**PLANNING APPLICATION P18-135**

**21-43 CLARENCE STREET, PERTH**

**ATTACHMENTS**

- A Application & plans, correspondence with applicant
- B Responses from referral agencies
- C Representations
- D IPD review of stormwater memo

Attachment: Plan of Subdivision – suggested stormwater flow

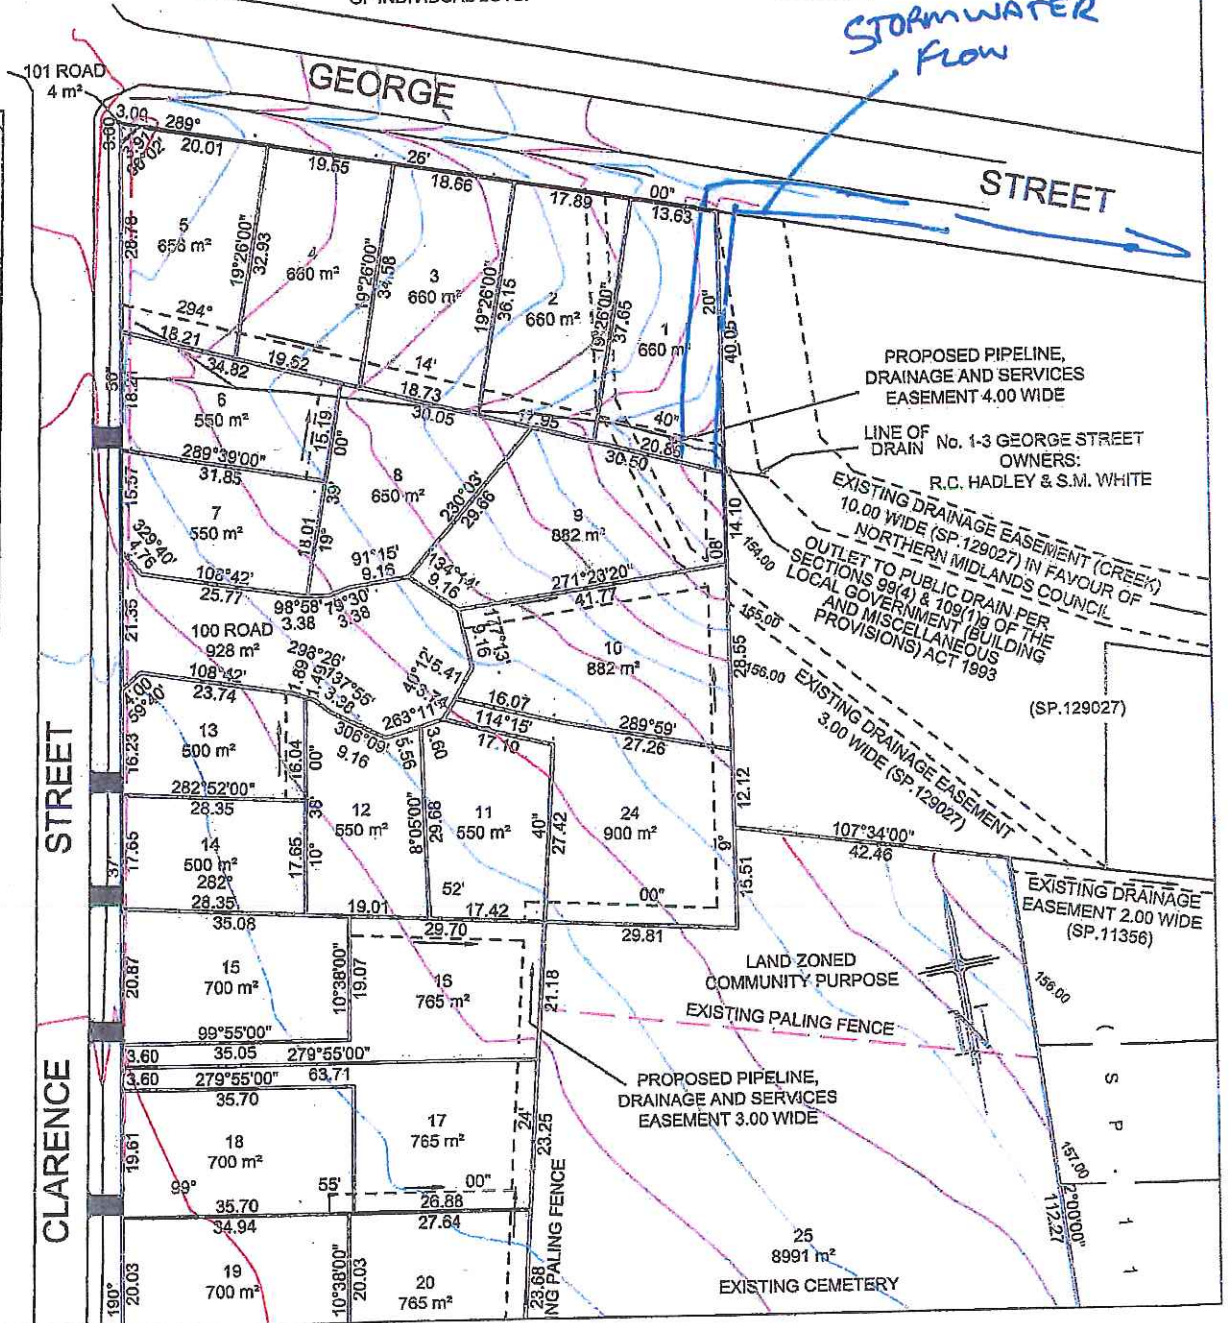
A major concern we have is the lack of information about what measures will be undertaken to deal with stormwater and sewerage from the proposed subdivision. Stormwater run-off from the block (as per the plans supporting the subdivision show) will be directed into the open easement (drain) across 1-3 George Street. We believe that increased stormwater run-off will have a significant impact on our land in terms of increased erosion not only during the development of the subdivision but also once houses are built. It is understood that the sewage line running from the Clarence Street property through to the pump station on the riverbank in William Street will require upgrading to accommodate increased flow.

We continue to have major concerns regarding this amended 25 lot subdivision as previously with the 28 lot subdivision, that the increase in stormwater created by this development will greatly impact out property in terms of erosion along the boundary fence as well as in the existing stormwater drain on our property at the very least. I posed an alternative suggestion at this meeting to your Planning Officer with respect to directing the stormwater out into George Street and then directly along George Street to the South Esk River (see attached plan). Your Planning Officer noted this suggestion and advised that he would investigate this as an alternative. We would appreciate being informed of the outcome of this investigation.

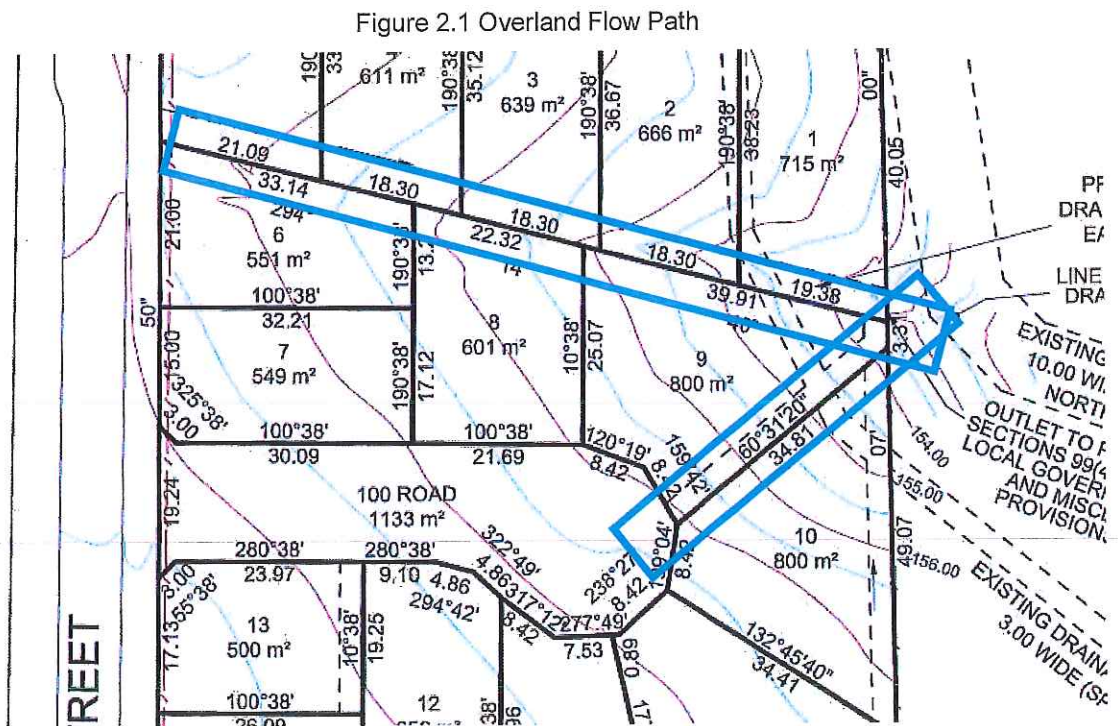
Given the underground pipe network cannot transfer flows greater than approximately a 20% AEP event (nominally 1 in 5 year recurrence interval), a significant portion of the predicted flow for events which occur less frequently than a 20% AEP will be overland flow. Without completing a comparison hydraulic model and a detailed site assessment of the overland flow path from Seccombe Street West

to George Street, it is not possible to determine accurate overland flow paths and the time of concentration of these flows to join this watercourse, assuming the overland flow paths lead to George Street. The proposed development and sub-catchment 05 from the HDNA report appear to have well defined overland flow paths, and as such they are likely to reach the watercourse fairly quickly for rare events.

As such, it is likely that the creek flows will be limited to nominally 2.5 m<sup>3</sup>/s from the greater catchment, for up to a 1% AEP event. This results in a proportional increase of flow as a result of the proposed development the more infrequent the rainfall event, which is not outlined in the HDNA memorandum. As an approximation, the increase in flow through the watercourse will likely range from 5% for a 20% AEP event (as per HDNA memorandum) up to potentially 12% for a 1% AEP event, if the overland flow paths are not well defined.

It is IPD's opinion however that the watercourse can handle this increase in flow based on the grade and geometry of the watercourse. However, based on the site visit undertaken at 1-3 George Street, increasing flow in the watercourse is likely to have a detrimental impact on the landowners amenity, particularly given the regular maintenance obviously undertaken by the landowner.

Contamination from the proposed development (runoff from bitumen surfaces, roofs etc) is a significant concern to the watercourse condition, especially with the removal of the existing grassed swale. The humeceptors as proposed by the developers will remove the majority of contaminants, however this requires ongoing regular maintained by NMC. Vegetated swale drains and other natural contaminant removal options (WSUD alternatives) are preferred from a long term viability perspective, similar to what has been installed at Edward Street.

An underground storage tank (Atlantis flow-tank modular system, precast concrete wells etc.) which is owned and maintained by NMC is a better long term solution for NMC, and fairly standard practice for subdivisions with downstream drainage network restrictions. Ideally above ground storage is better as it provides both detention, and also some degree of stormwater treatment if appropriately designed and vegetated, and generally cheaper to construct than underground storage. The available storage volumes for these options can be significant, and can provide as much detention as required to negate the impact of the development.

Given the proximity to the natural watercourse, a vegetated above ground stormwater detention basin would negate the need for humeceptors (and the associated maintenance requirement), and provide a reliable means of retarding stormwater discharge from the site.
